CHANCE
MANUFACTURING CO., INC.

Service Information

Ride: ZIPPER

Subject: SEAT SAFETY LUG BOLT CHECK

FIGURE A

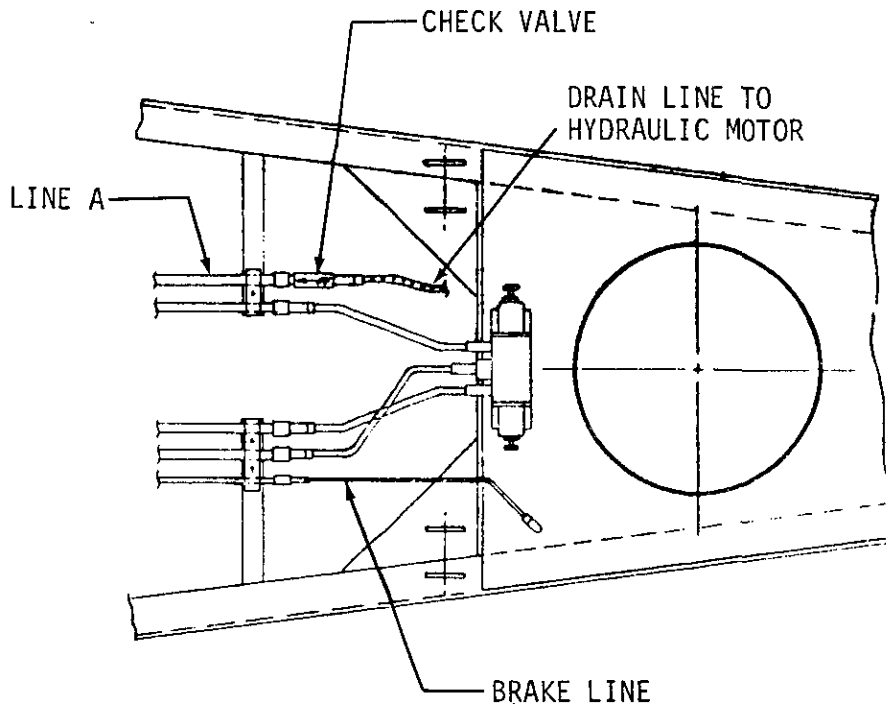
Inspect hydraulic plumbing for check valve position as shown in FIGURE A.

Trace routing of line A, it should run directly to hydraulic reservoir and not be tied into any other lines.

If this check valve is not in position shown, contact Chance Manufacturing Co. for instructions in replacement.

FIGURE A

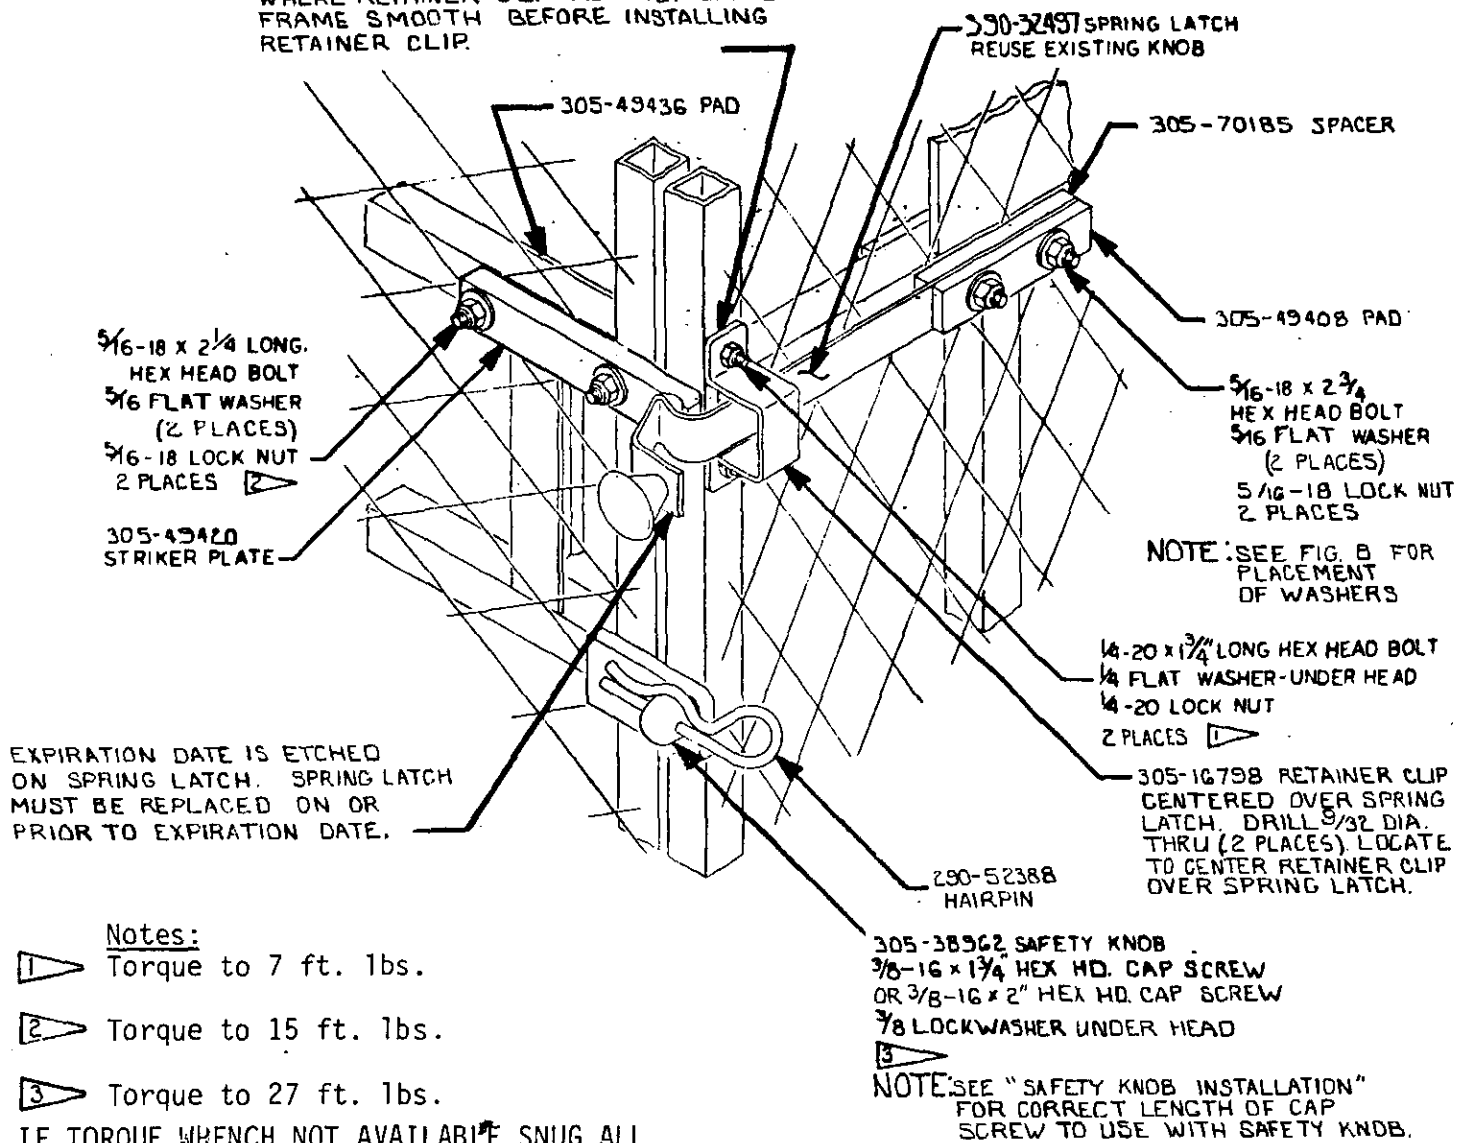
REMOVE EXPANDED METAL FROM FRAME WHERE RETAINER CLIP MOUNTS. GRIND FRAME SMOOTH BEFORE INSTALLING RETAINER CLIP.

Install the 305-49420 Stricker Plate and 305-49436 Pad on the door. Position the Stricker Plate as shown in figure B. Torque attaching bolts to 15 ft. lbs.

FIGURE B

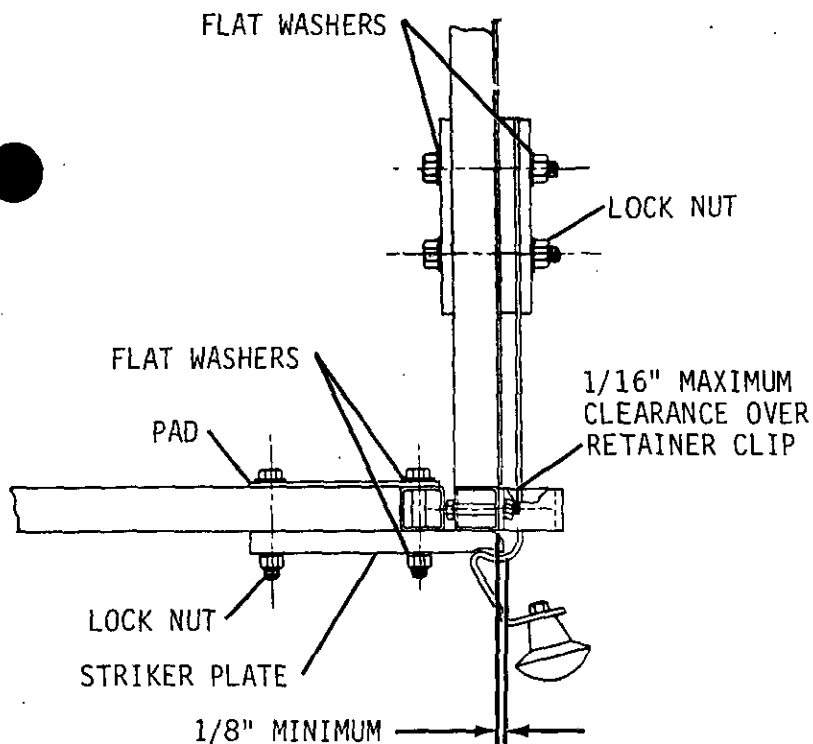
The 390-32497 Spring Latch on each seat must be checked daily. The Spring Latch must be centered on the 305-49420 Striker Plate and should clear the base of the 305-16798 Retainer Clip no more than $1/16$ " as shown in figure B thus insuring adequate overlap of Spring Latch and Striker Plate and preventing the door from opening unless released by pulling on Spring Latch knob. Spring Latches which clear the base of the Retainer Clip more than $1/16$ should be replaced immediately and the seat not used until this has been done. (FIGURE B) Do not attempt to straighten or repair the Spring Latch in any way. Each Spring Latch must be replaced on or before the expiration date (month and year) etched at the knob end.

When installed, the striker plate should extend a minimum of 1/8" beyond the edge of the frame.
